From : Kevin Carroll <kev_scout@hotmail.com>
Sent : Sunday, October 23, 2005 2:03 AM
To : kev_scout@hotmail.com
Subject : Permit Application

From : Kevin Carroll <kev_scout@hotmail.com>
Sent : Sunday, October 23, 2005 2:01 AM
To : building@springdale.org
CC : kev_scout@hotmail.com
Subject : Permit Application Supplemental Info

Re: Permit Application – 658 Cloverdale Avenue, Springdale OH
Request for Revisions

To construct a 16' patio roof according to approved plans. 658 Cloverdale Avenue

DRAWING 2
Patio Roof Dimensions and Location:
~37' long by 15'6" deep
~42'8" from North (rear) property line
~44'11" from East property line
~15' from West property line

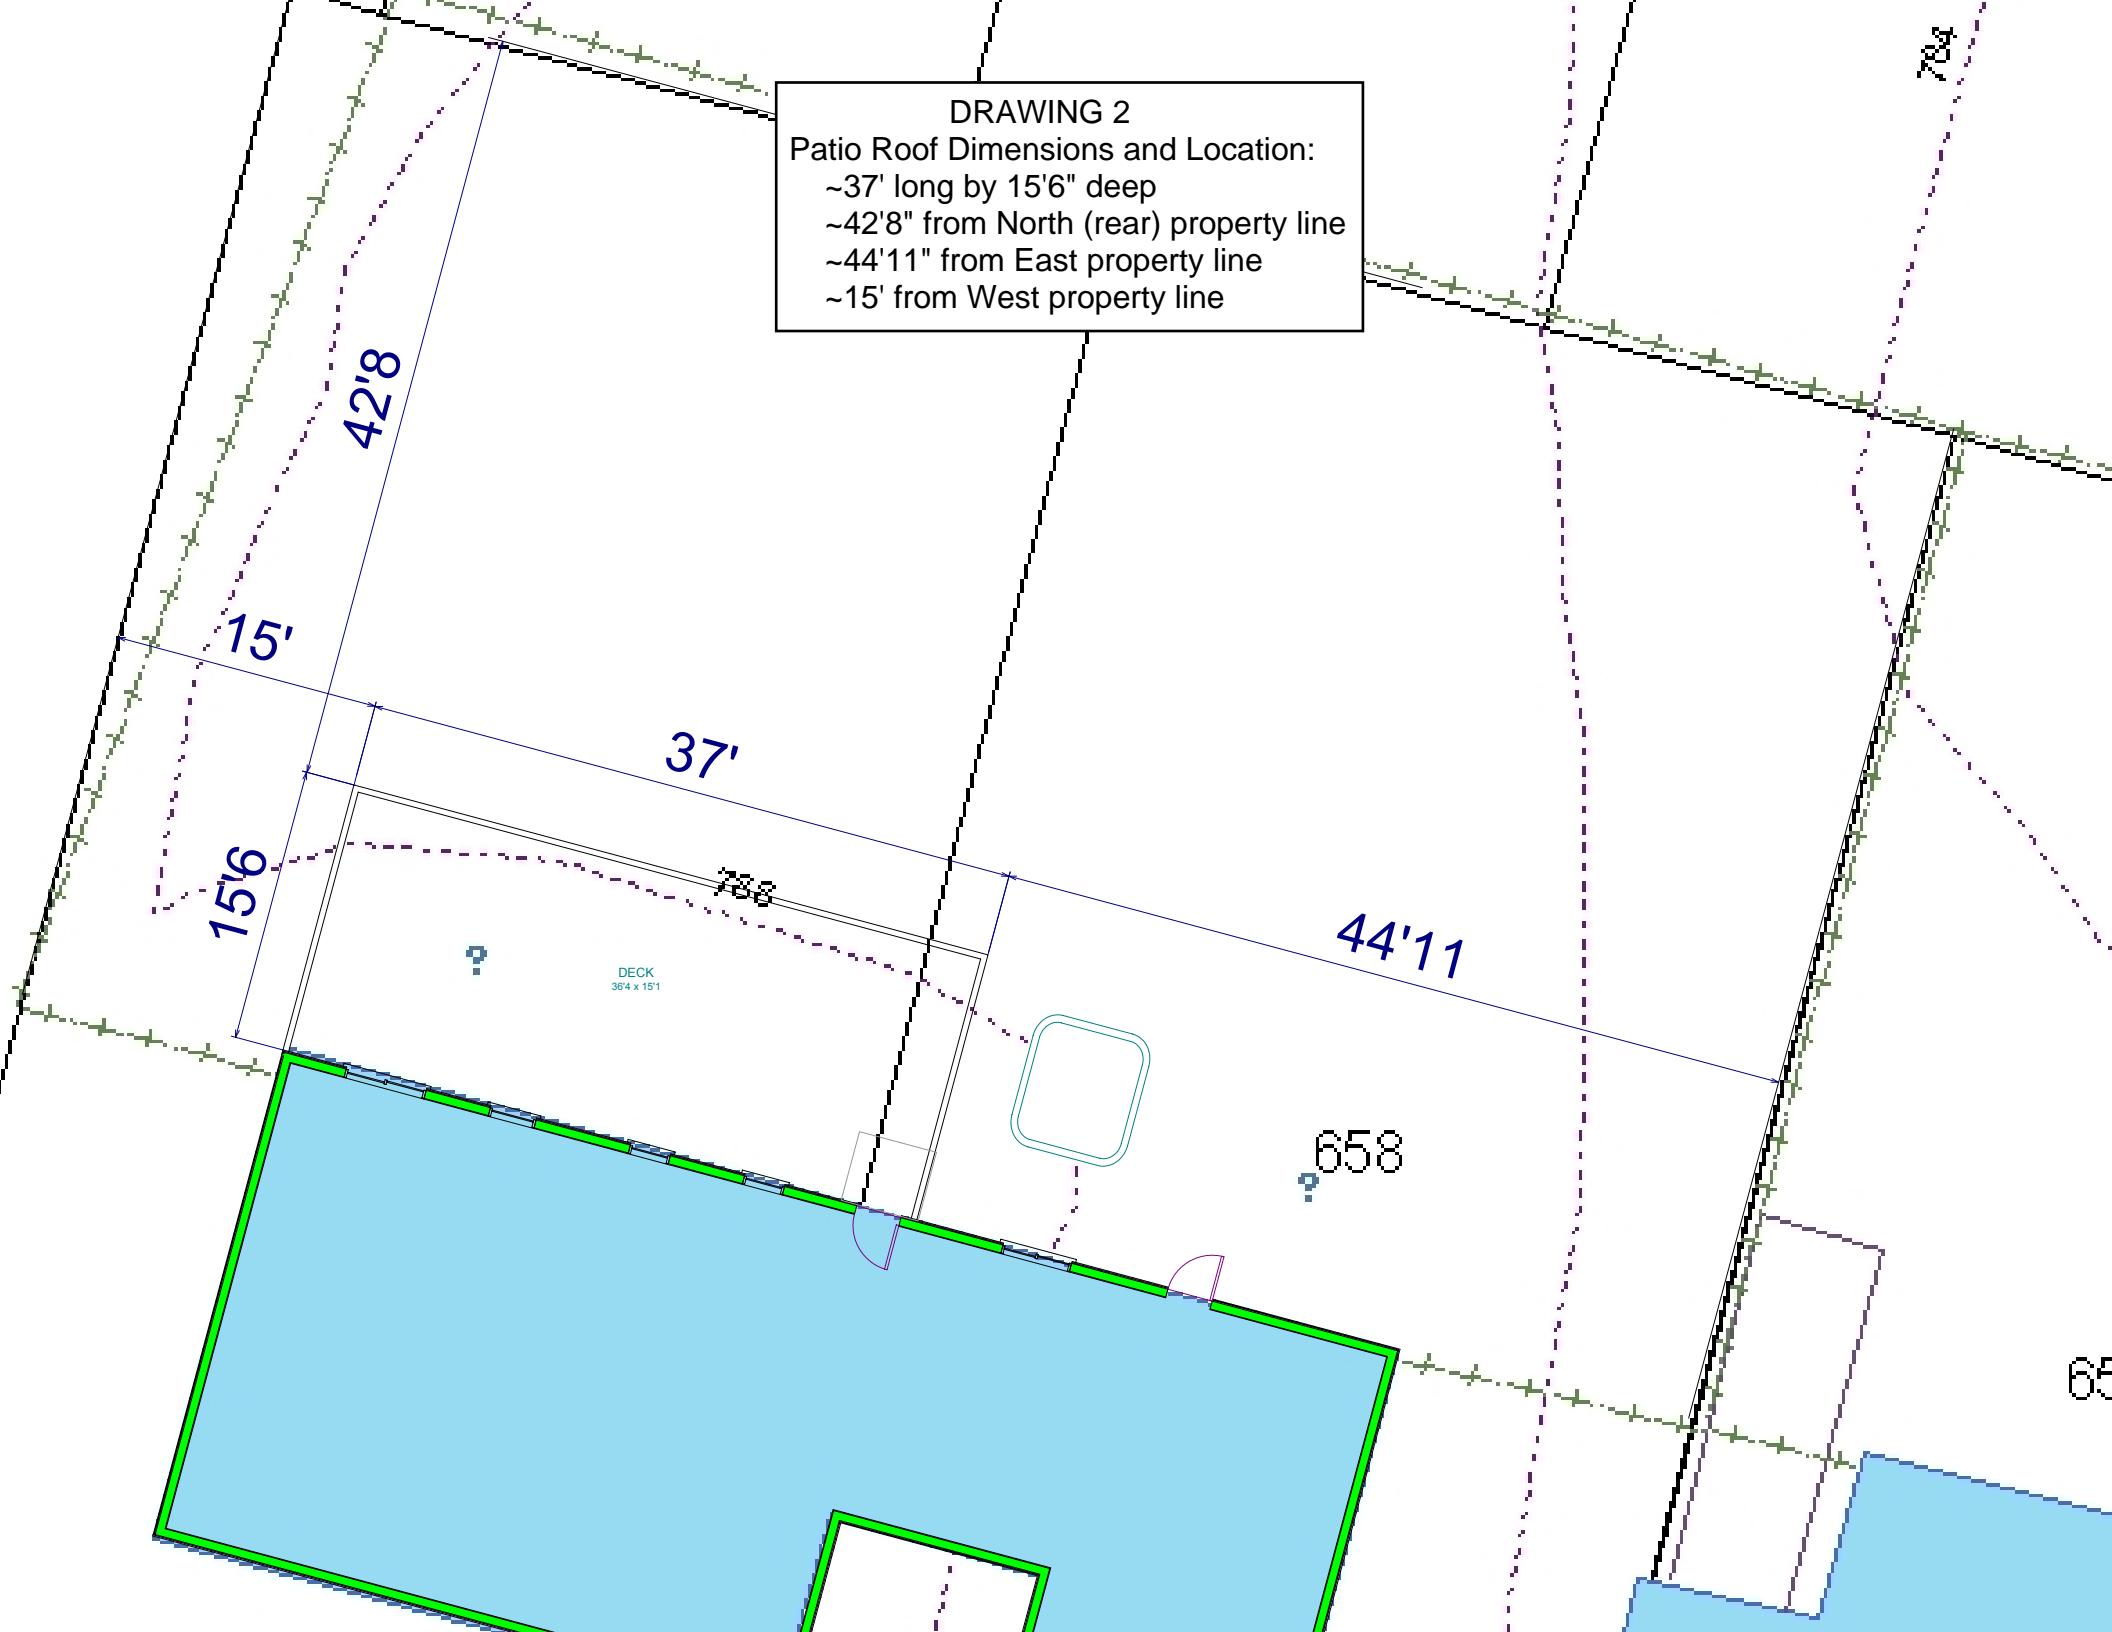
1. "Submit site plan showing distance to property lines."

This was attached previously as "Drawing 2". I have edited the document with some corrections/clarifications. First, I corrected the misspelling of "North". Second, I added red lines to clarify the beginning and end of the dimension lines. Finally, I changed the color of the dimension text to make it more obvious. Please let me know if it was missing any details.

DRAWING 5
"Floor Plan"

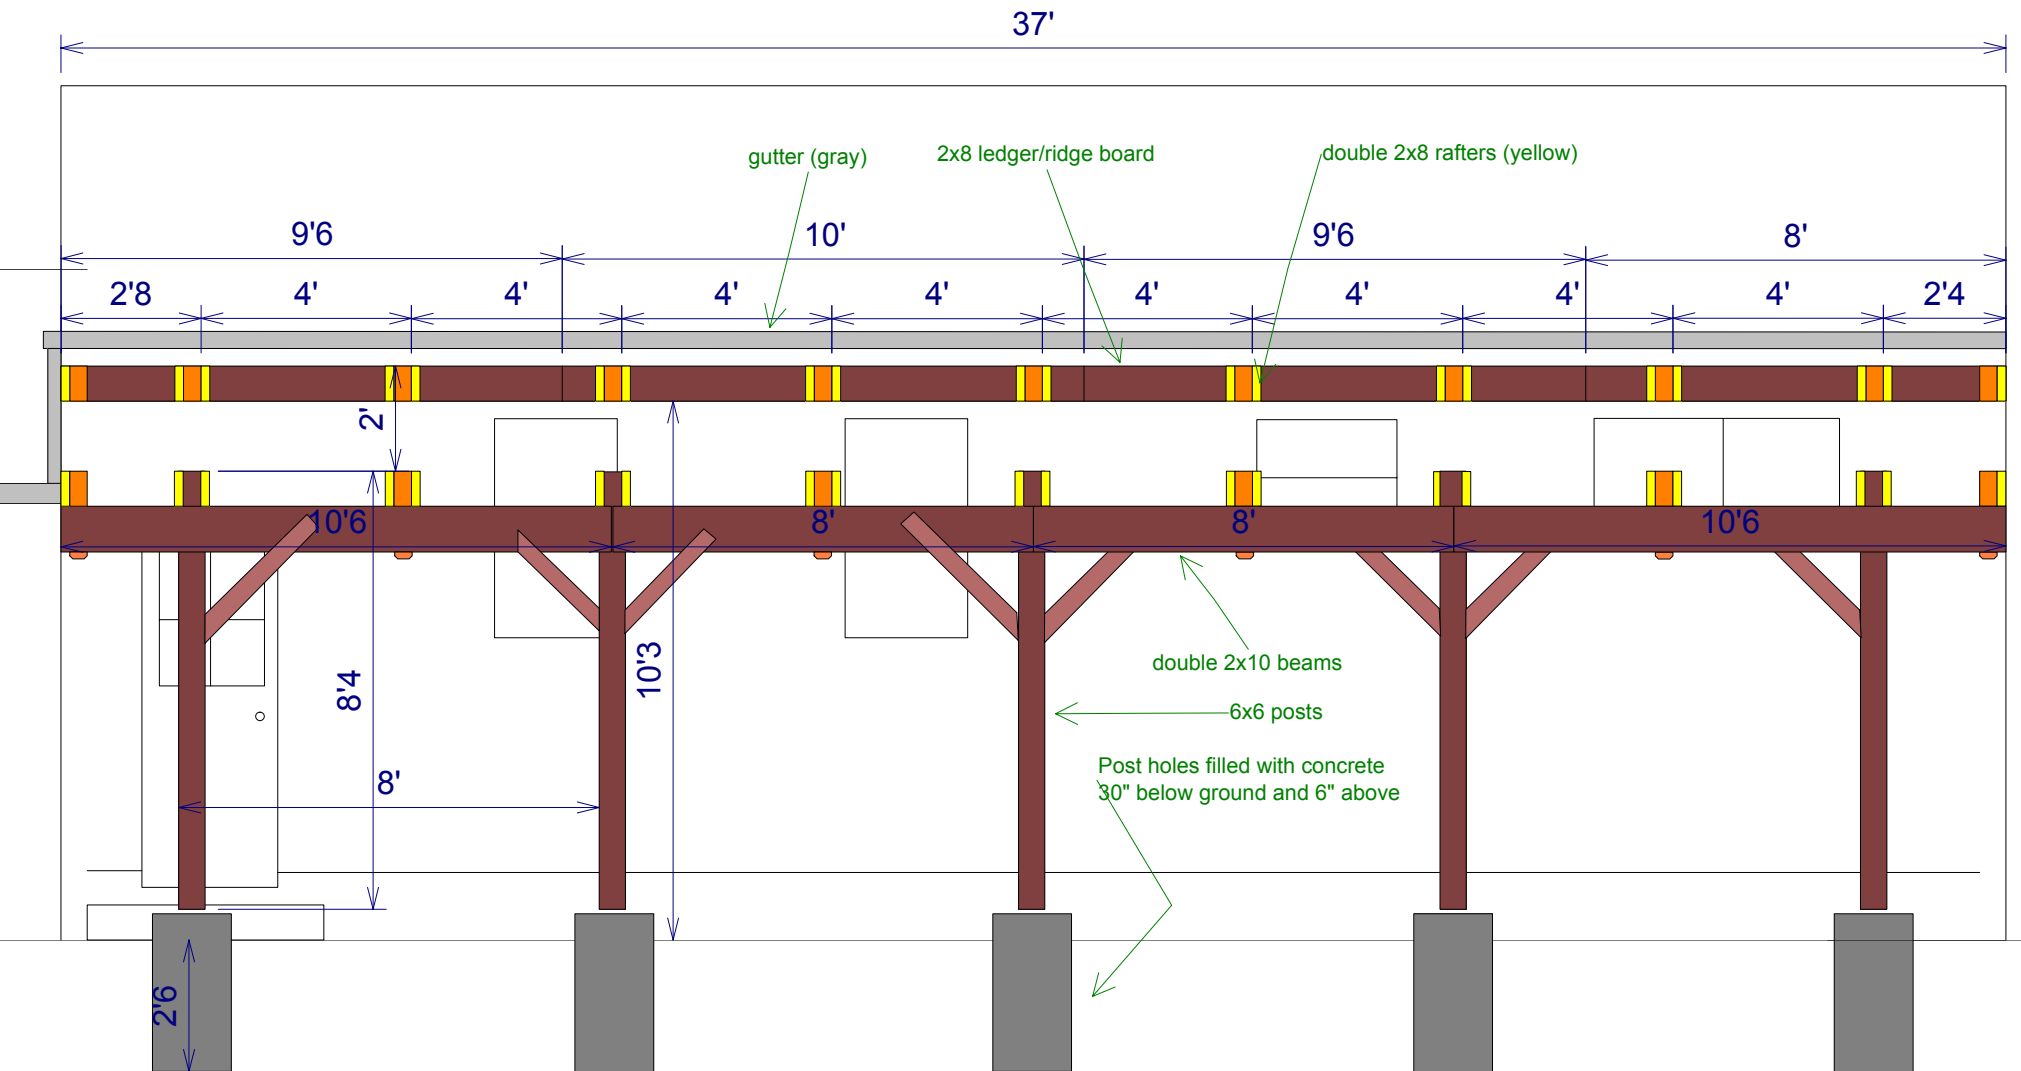
2. "Submit floor plan showing posts with dimensions."

All posts are 6" x 6" and are 12' from the house on 8' or 10' spacing. The only 4x4s used are the 12" spacers. Both can be seen in "Drawing 3". I have included an additional drawing showing the detailed "floor plan". It is attached as "Drawing 5".
